SKYLINE AT LORSON RANCH FILING NO. 1

STREET AND STORM SEWER CONSTRUCTION PLANS

**AS-BUILT
STREET-STM
FEB 2, 2023**

SF-22-001

SHEET NUMBER C1.2

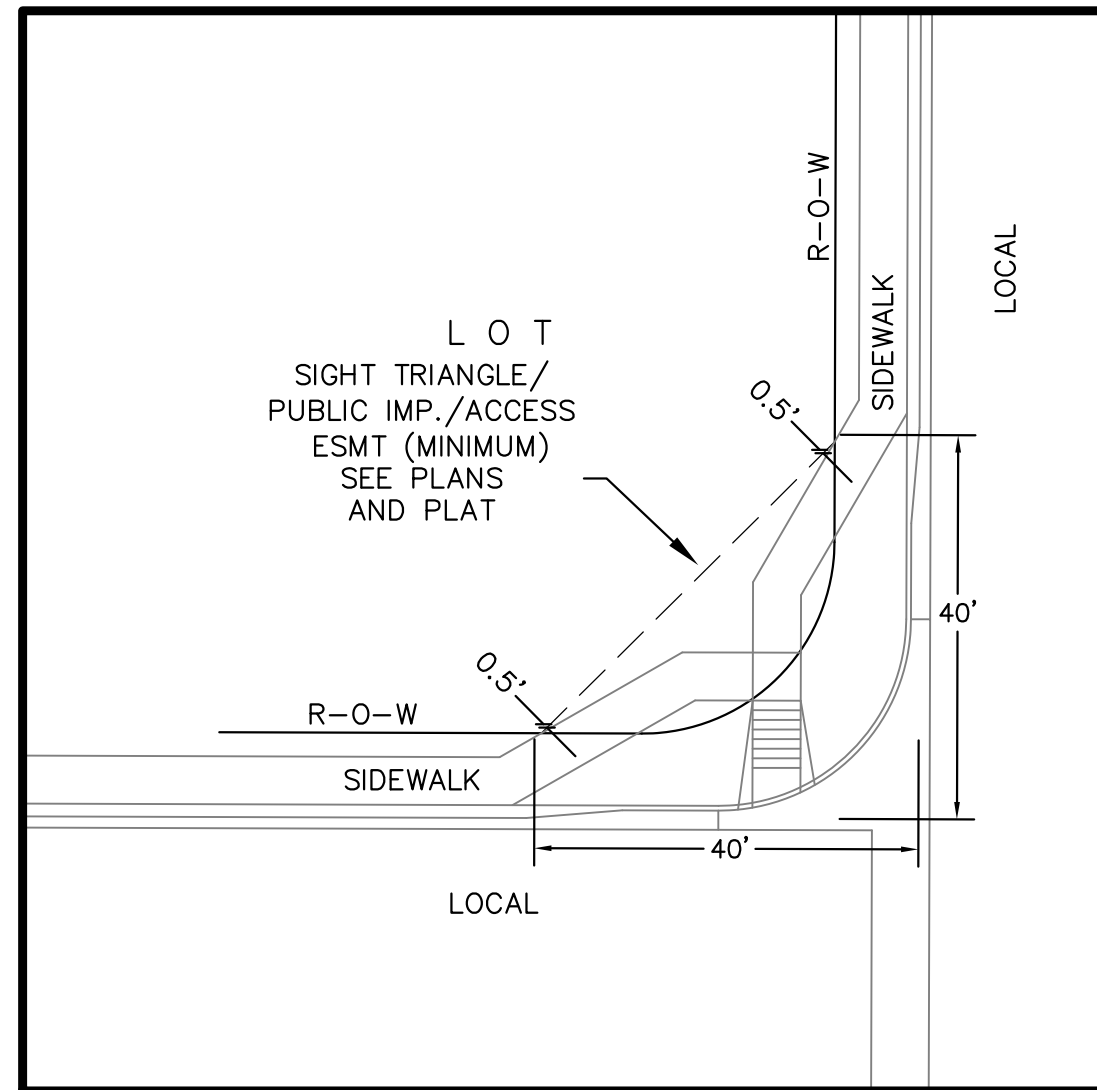
Please see comment on the cover sheet. Engineer of record should include stamp, signature, and date per ECM Chapter 5.10.6C on all sheets.

**GRAYLING DR & LAMPREY DR
SIGNING & STRIPING PLAN**

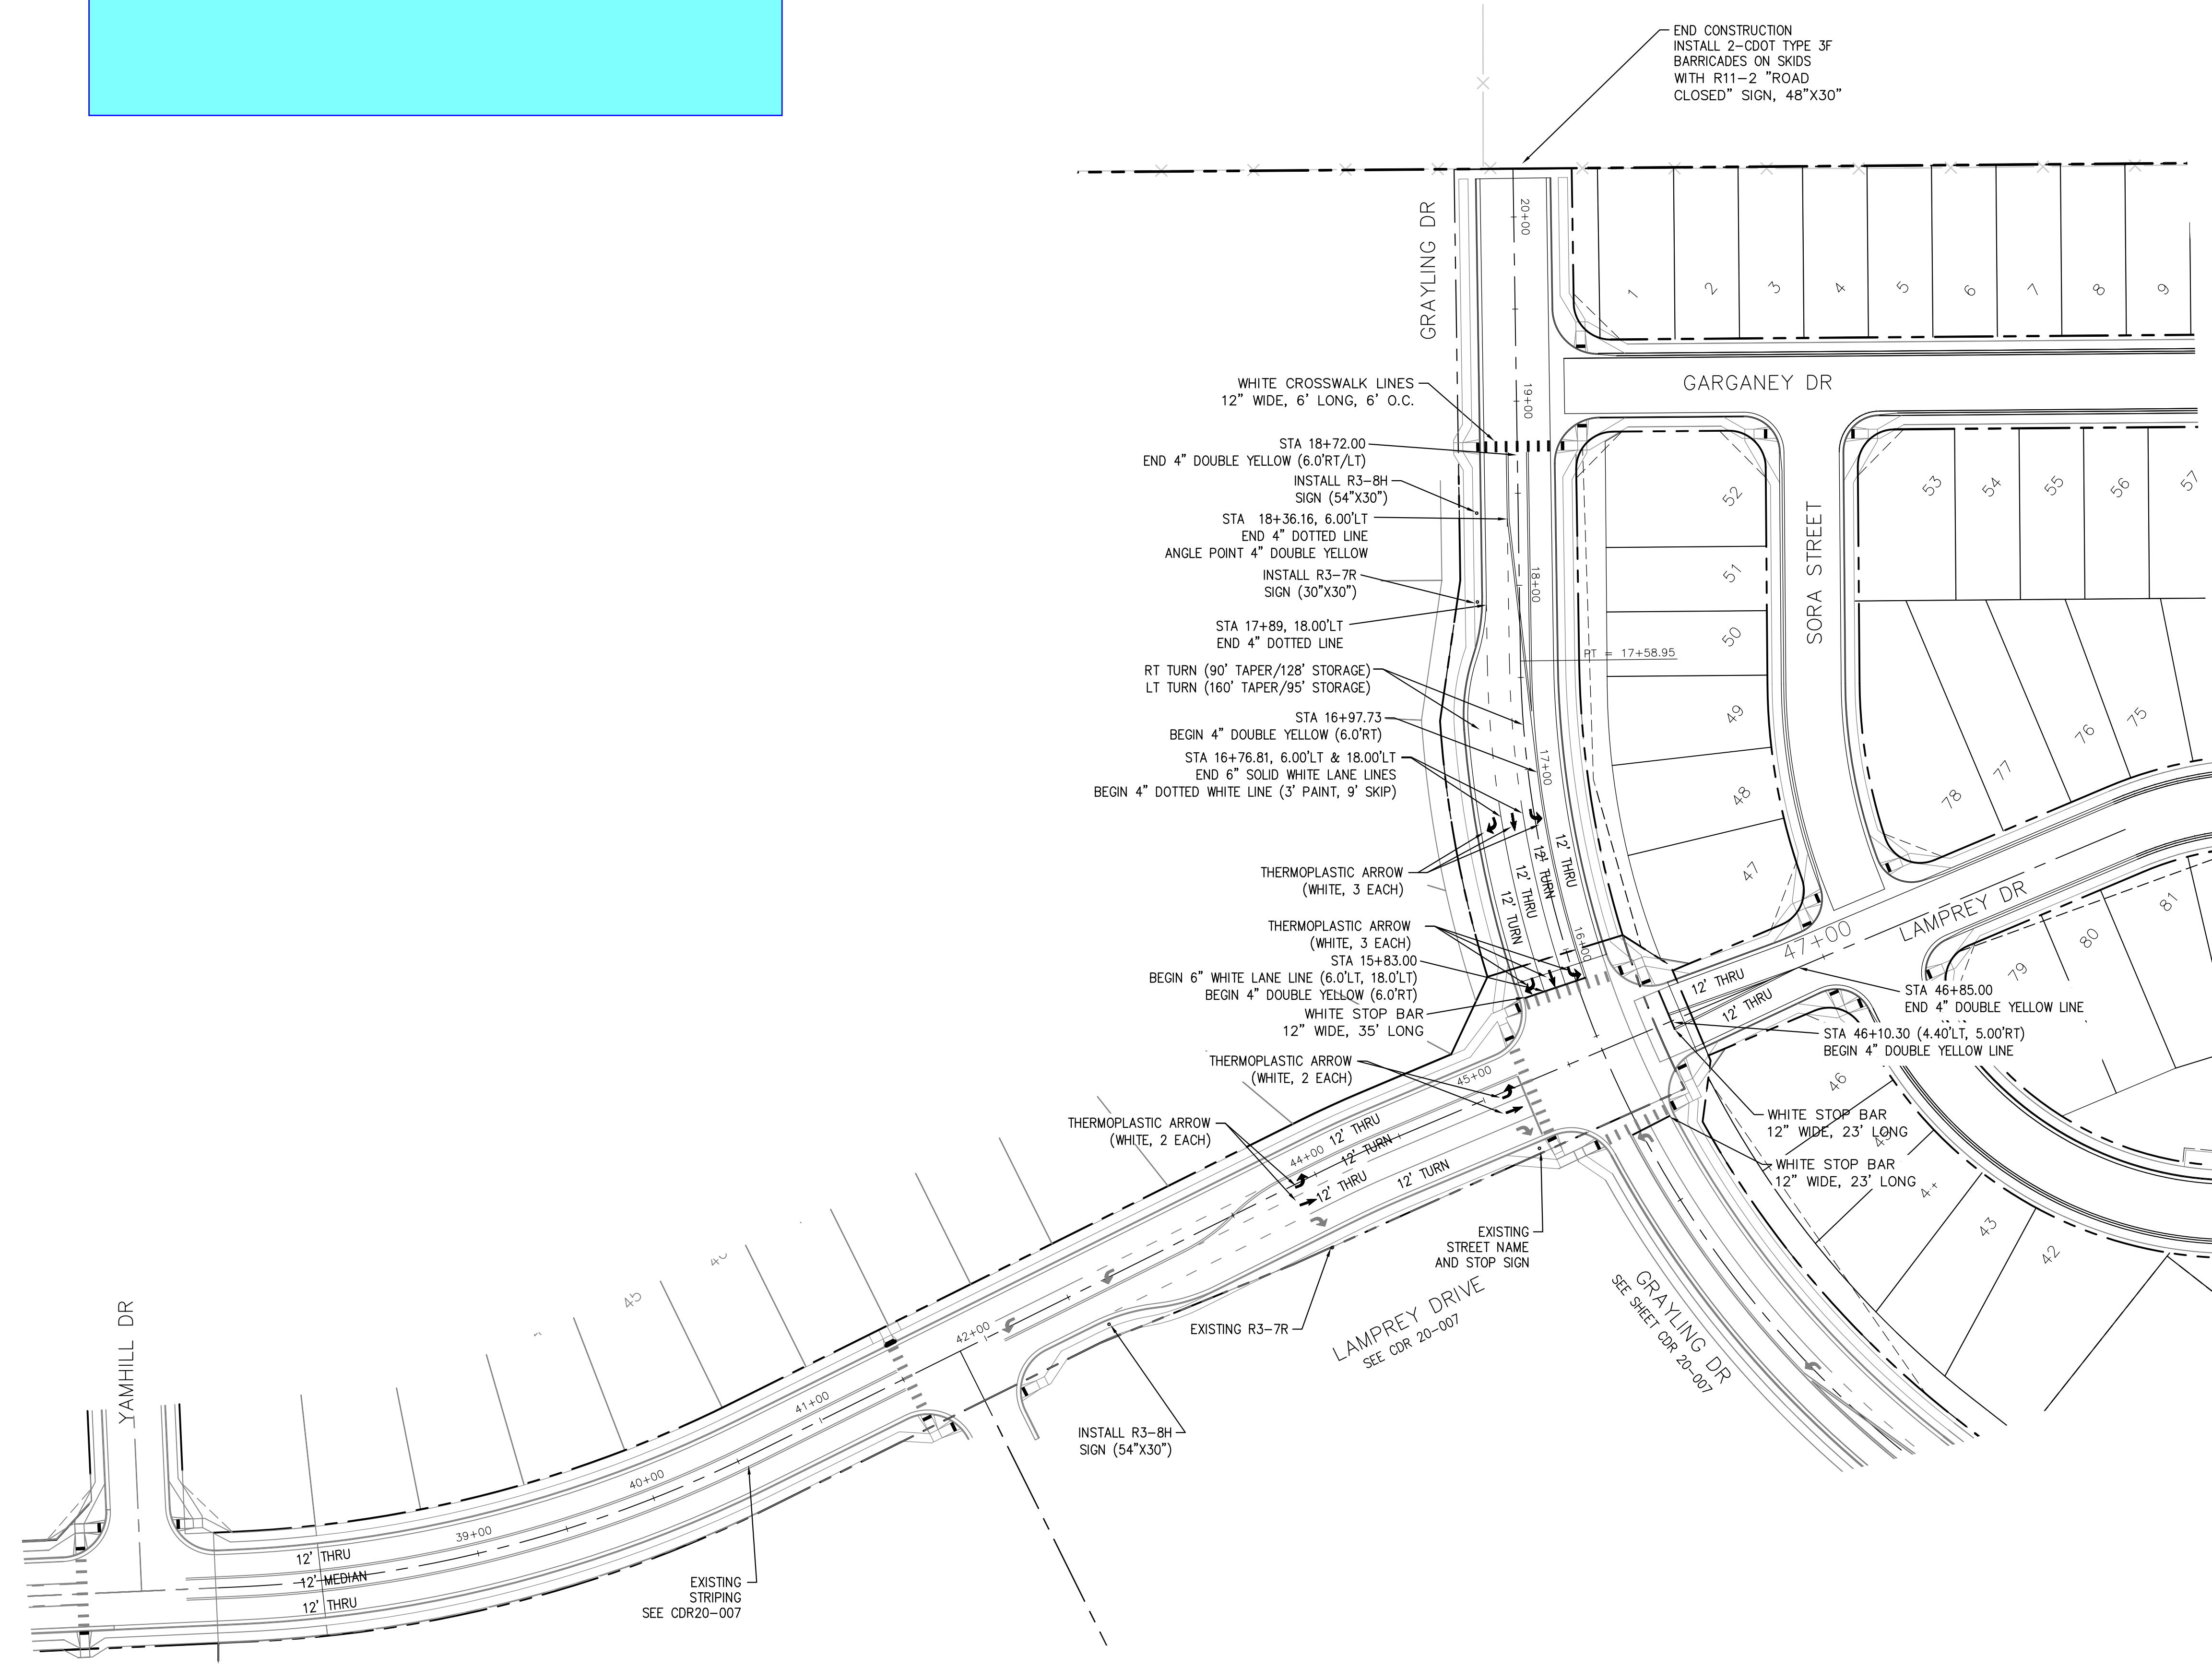
Please update drawings to reflect deferred sidewalks. Please highlight the sidewalks that have been deferred and add a note to clarify the sidewalks have not been built and are deferred per SF221 sidewalk addendum.
